2400
9.14m LOTS
GARDEN 3 (GR)
ELEVATION 1, 2 & 3
A1 PACKAGE
O.REG. 332/12

CITY OF CAMBRIDGE BUILDING DIVISION THESE PLANS have been examined for compliance with the Ontario Building Code Requirements. A Building Permit is in order to issue subject to any changes noted under the condition that the building will be constructed in accordance with the code Inspector: Thomas Weathers Date: 2023-03-08

TITLE SHEET	
BARLASSINA CONSTRUCTION CITY OF CAMBRIDGE

BASEMENT PLAN EL-3
BARLASSINA CONSTRUCTION
CITY OF CAMBRIDGE

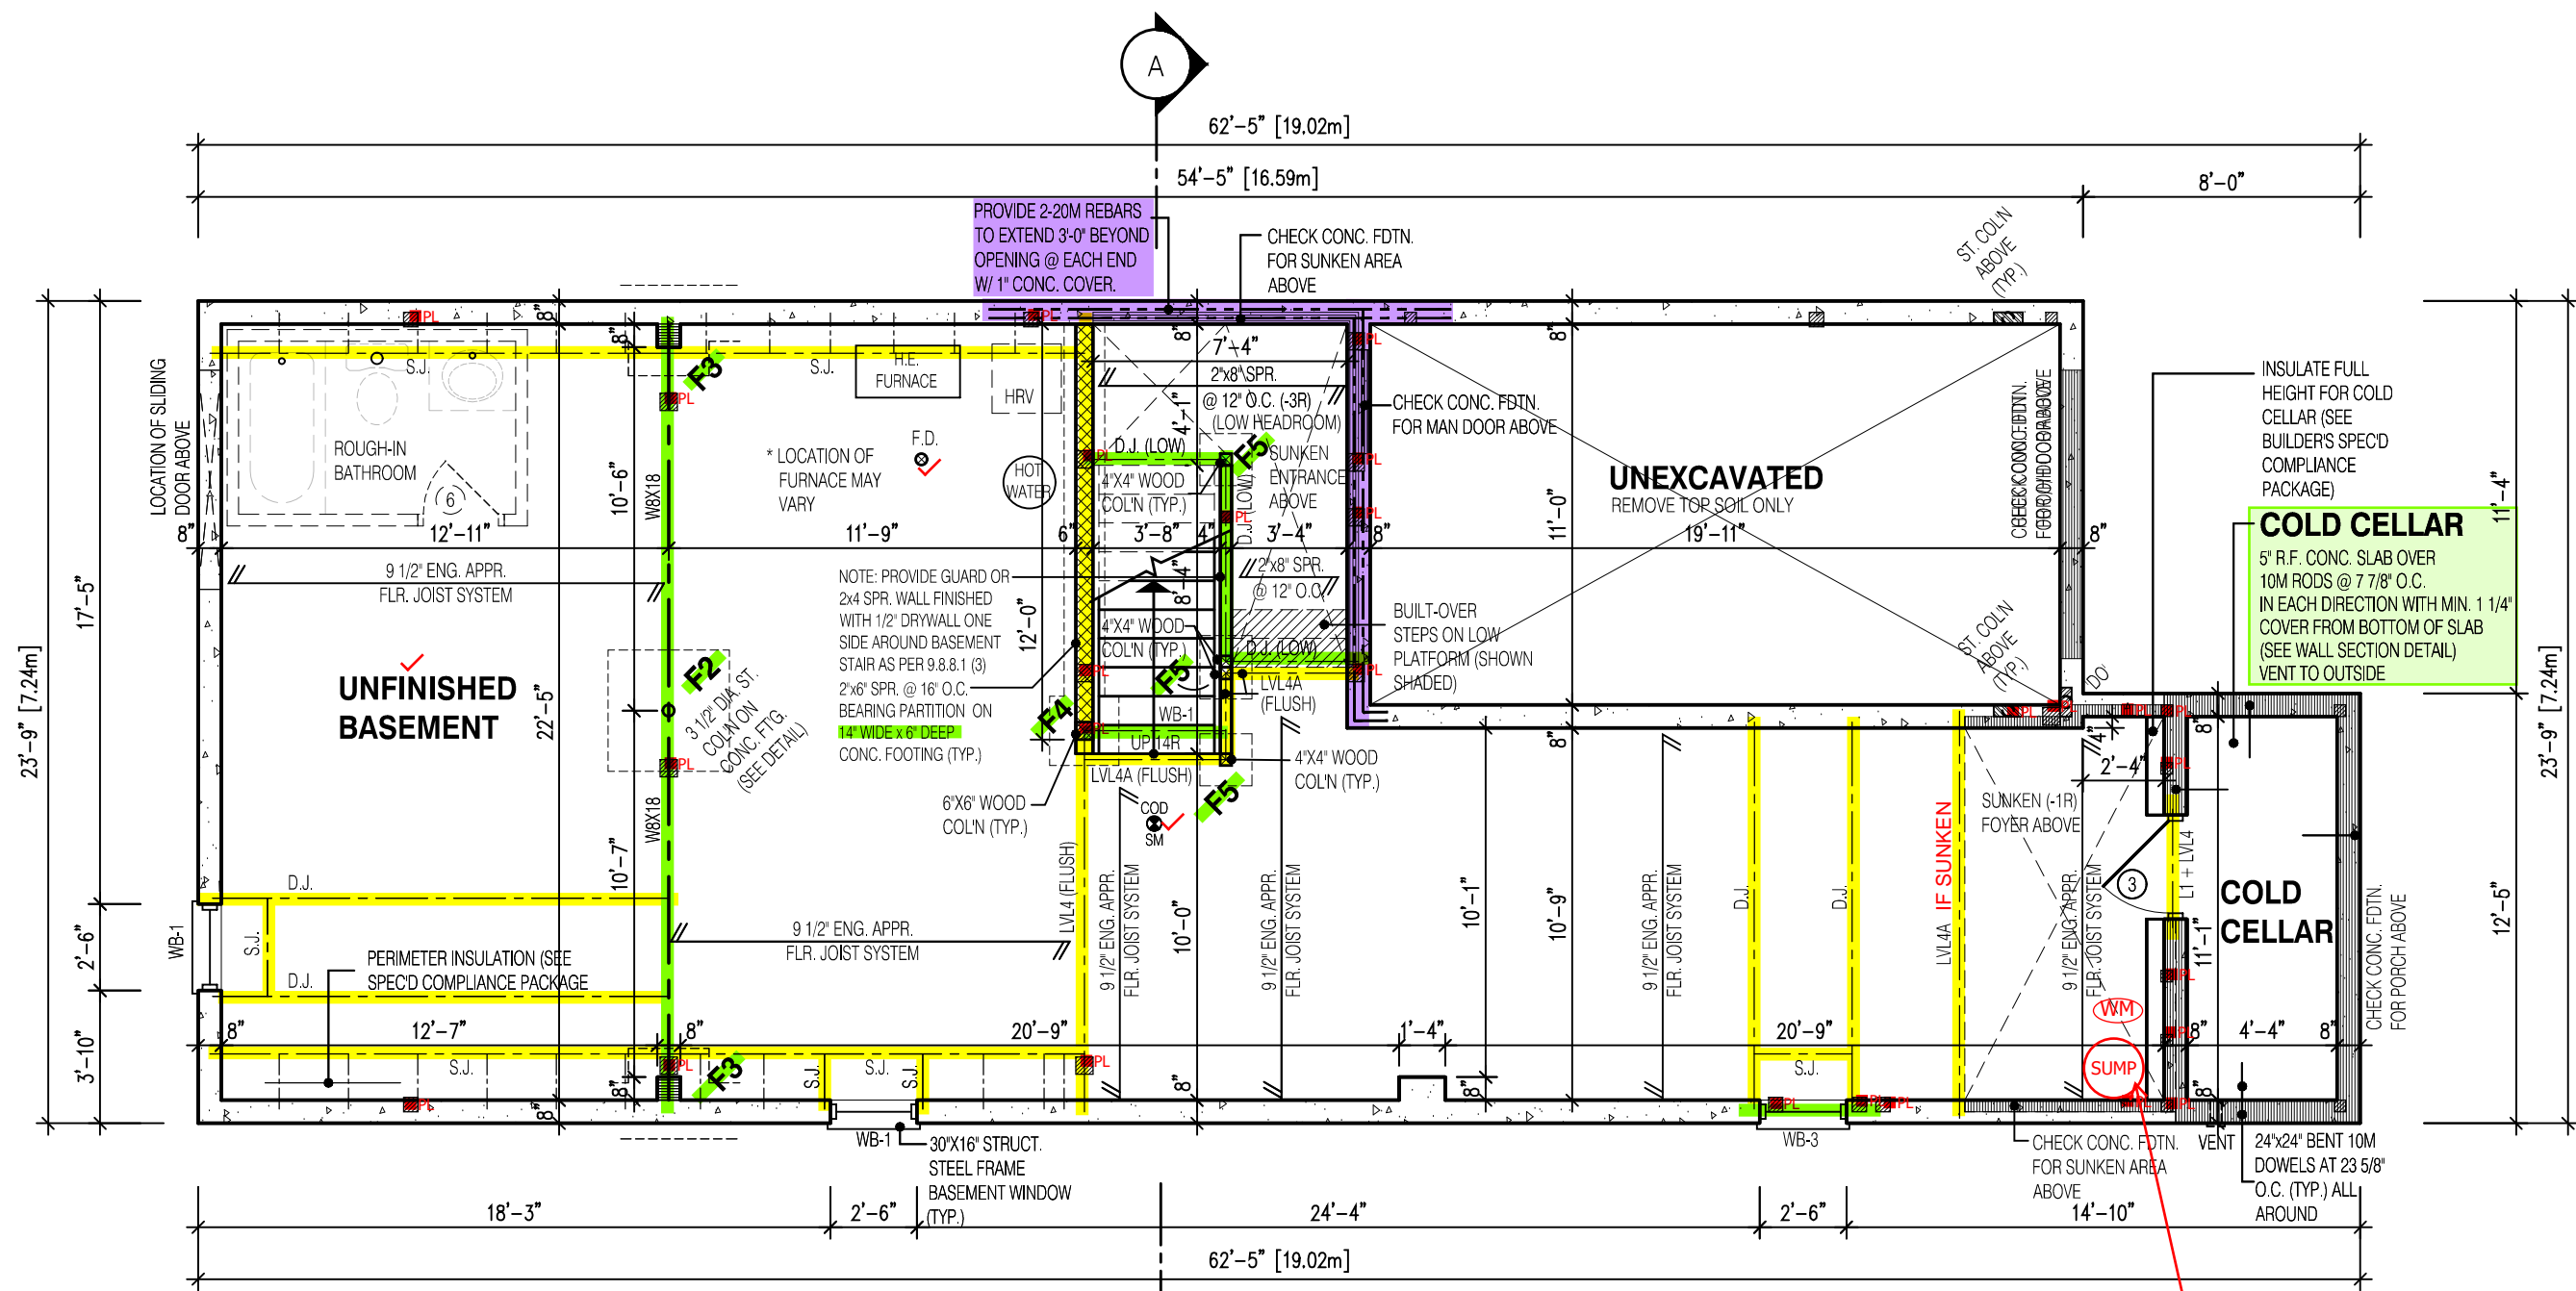
REQUIRED CONTINUOUS INSULATION CANNOT BE INTERRUPTED BY FRAMING MEMBERS SUCH AS STUDS

NON-LOAD BEARING WALLS NOT PERMITTED TO BE FRAMED (TYP.)

MINIMUM CEILING HEIGHT 6'-11"
MINIMUM CEILING HEIGHT UNDER BULKHEADS 6'-5"

VERIFY WATER METER AND DWHR UNIT LOCATION WITH INSPECTOR

SPRAY FOAM/RIGID INSULATION TO BE PROTECTED AS PER 9.10.17.10.(1)

WATER METER TO BE INSTALLED WITHIN 2m (6'-6") FROM THE POINT THE WATER SERVICE PIPE MEETS THE BUILDING LINE

FIRST FLOOR PLAN EL-3
BARLASSINA CONSTRUCTION
CITY OF CAMBRIDGE

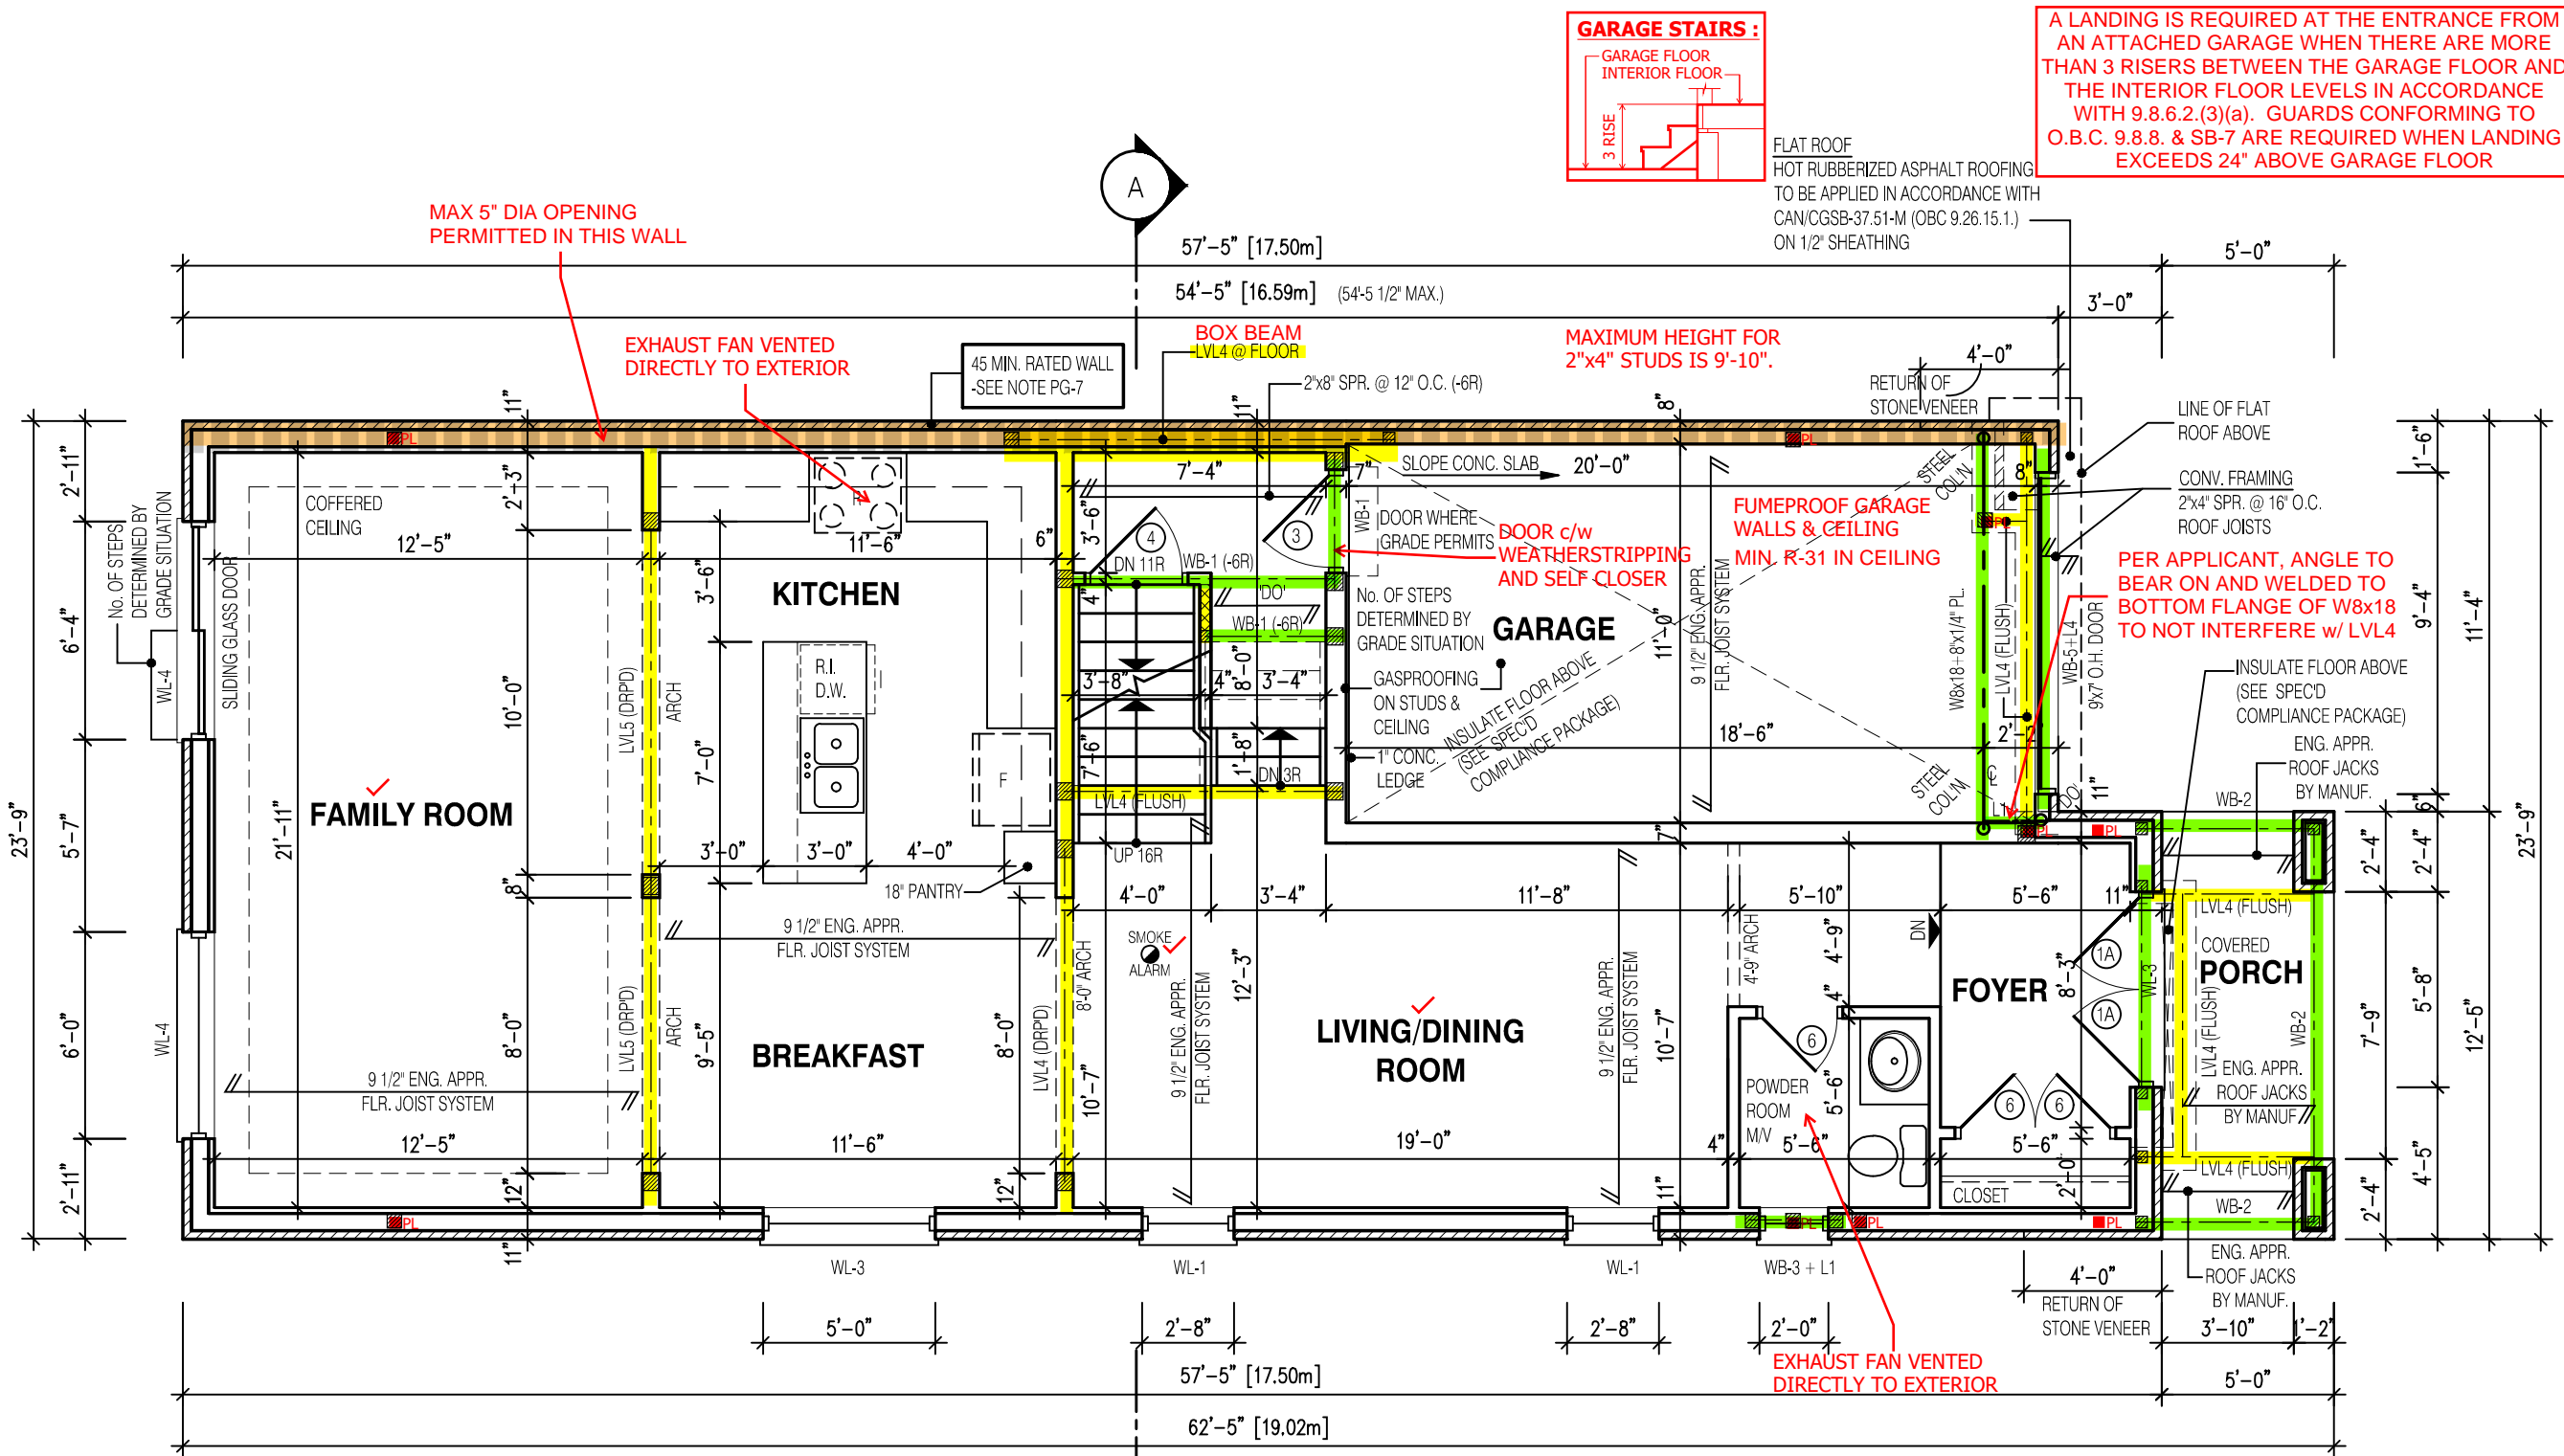
A LANDING IS REQUIRED AT THE ENTRANCE FROM AN ATTACHED GARAGE WHEN THERE ARE MORE THAN 3 RISERS BETWEEN THE GARAGE FLOOR AND THE INTERIOR FLOOR LEVELS IN ACCORDANCE WITH 9.8.6.2.(3)(a). GUARDS CONFORMING TO O.B.C. 9.8.8. & SB-7 ARE REQUIRED WHEN LANDING EXCEEDS 24" ABOVE GARAGE FLOOR

FLAT ROOF
HOT RUBBERIZED ASPHALT ROOFING
TO BE APPLIED IN ACCORDANCE WITH
CAN/CGSB-37.51-M (OBC 9.26.15.1.)
ON 1/2" SHEATHING

*TRACE ALL POINT LOADS THROUGH FLOOR SYSTEM TO SOLID BEARING BELOW

SEC. FLOOR PLAN EL-3
BARLASSINA CONSTRUCTION
CITY OF CAMBRIDGE

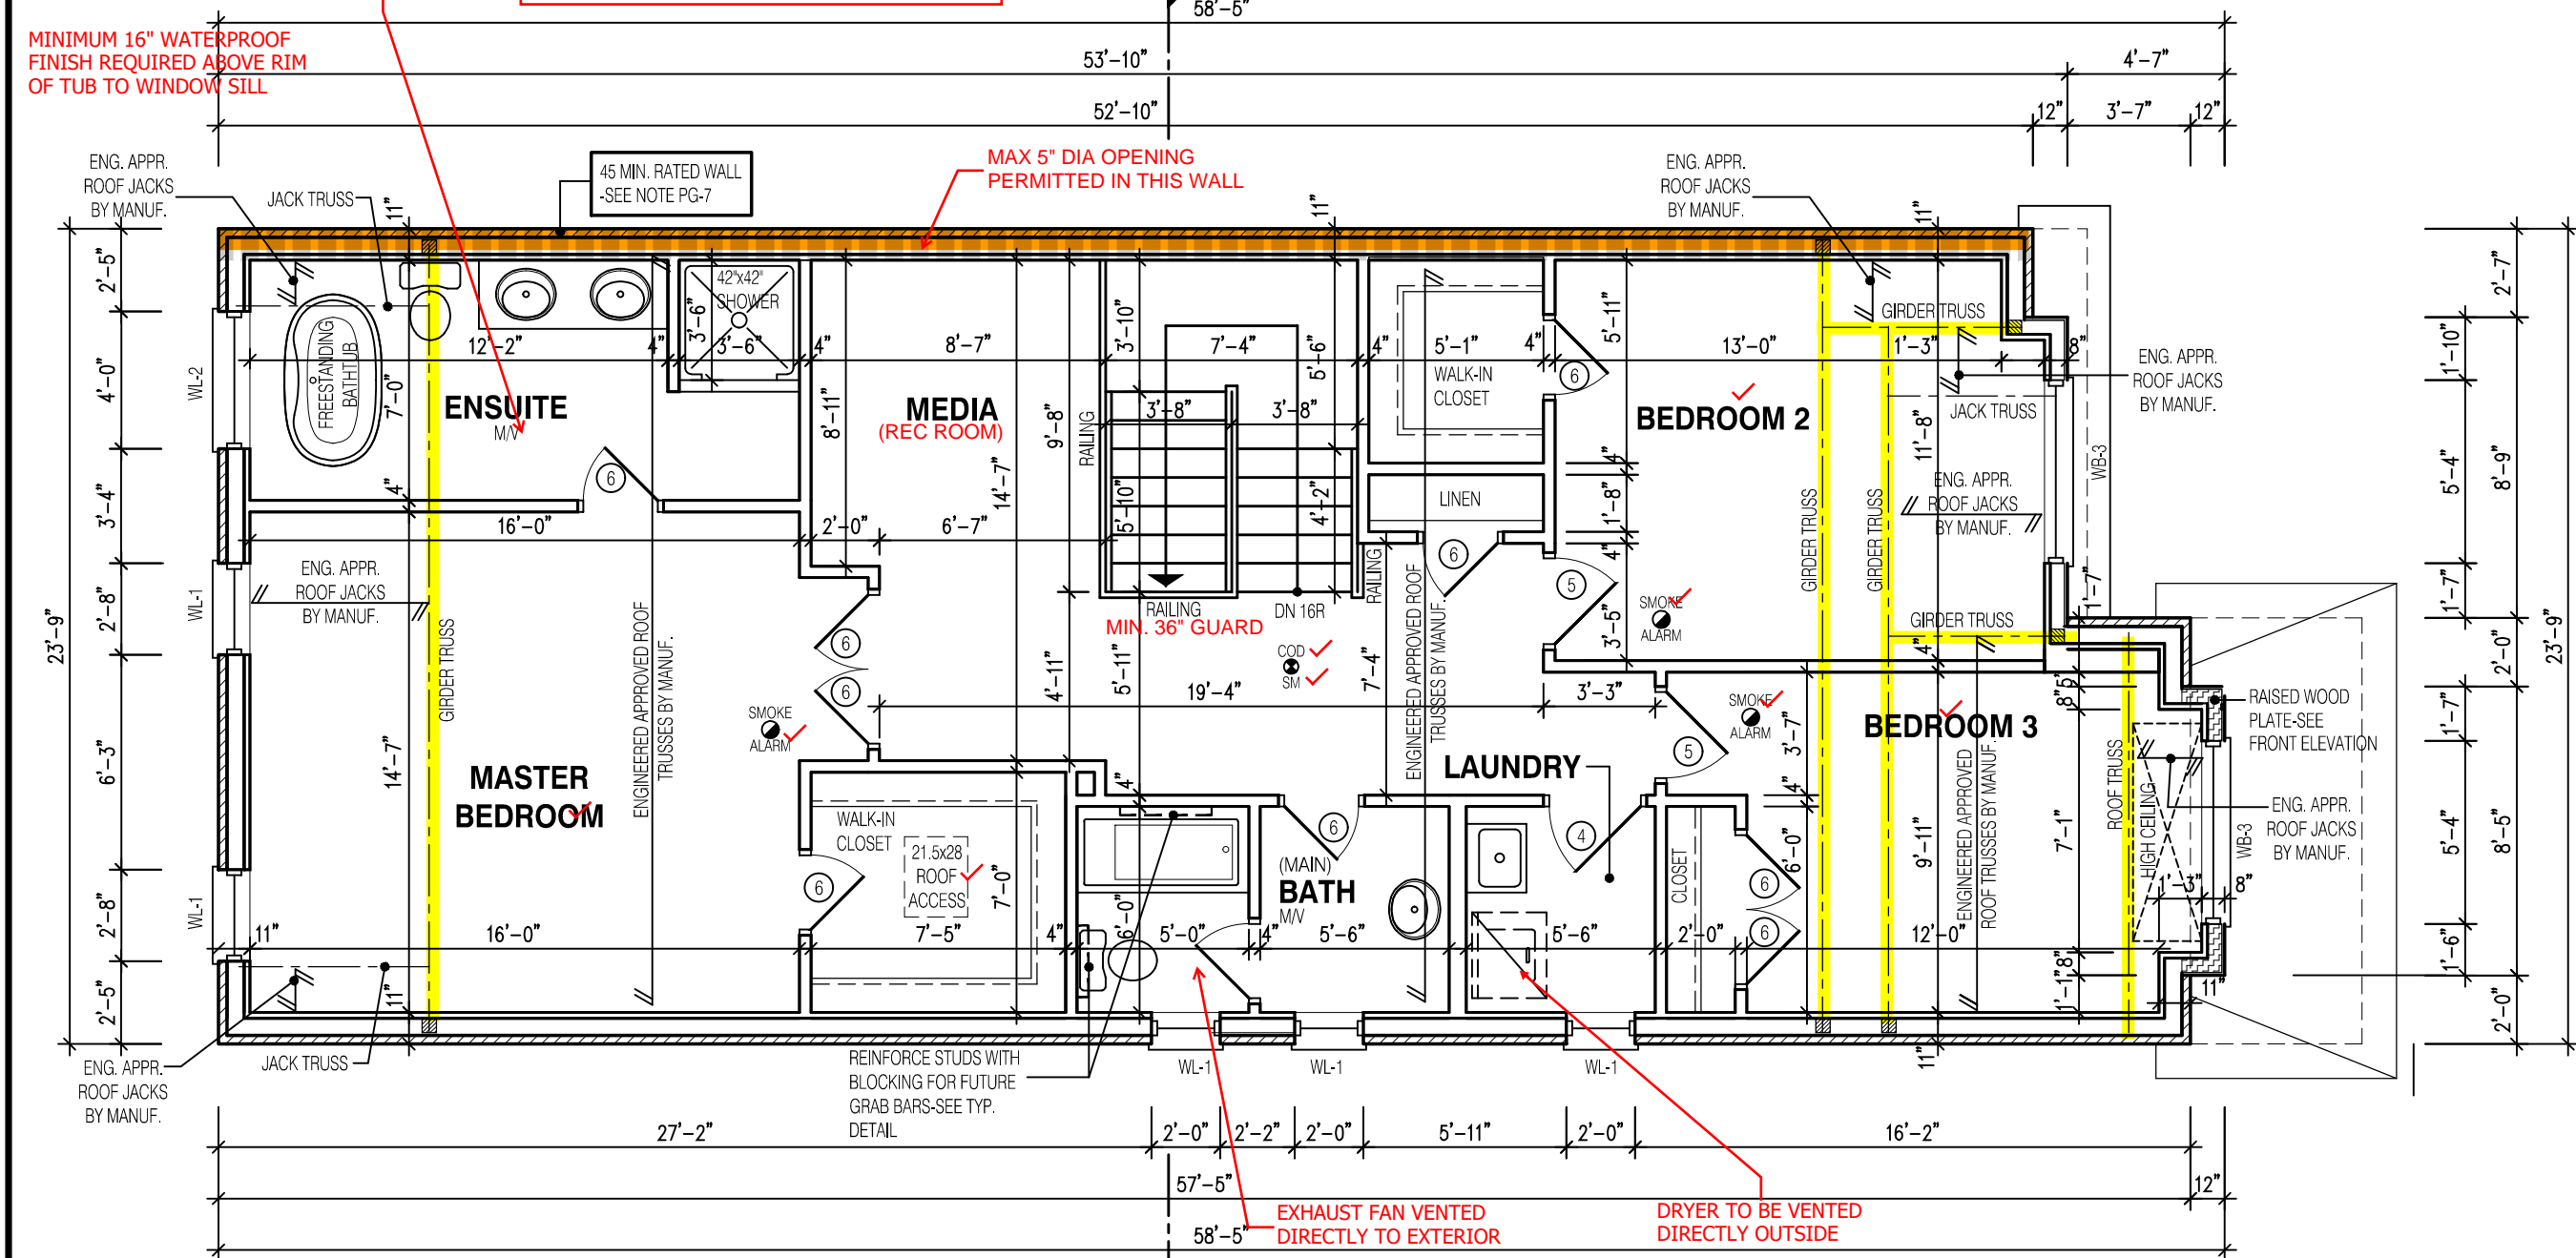
1 WINDOW SHALL PROVIDE AN UNOBSTRUCTED AREA OF 3.8SF w/ NO DIMENSION LESS THAN 15". WINDOW SILL TO BE MAX 39-3/8" ABOVE FINISHED FLOOR.

MAIN BATHROOM TO HAVE STUD BLOCKING FOR FUTURE INSTALLATION OF GRAB BARS ADJACENT TO SHOWER/TUB AND TOILET.

EXPOSED BUILDING FACE REQUIRES A 45MIN F.R.R. w/ 5/8" TYPE "X" DRYWALL & STUDS FILLED w/ INSUL. HAVING A MASS NOT LESS THAN 1.22 KG/M² WHERE LIMITING DISTANCE < 1.2m

EXHAUST FAN VENTED DIRECTLY TO EXTERIOR

MINIMUM 16" WATERPROOF FINISH REQUIRED ABOVE RIM OF TUB TO WINDOW SILL
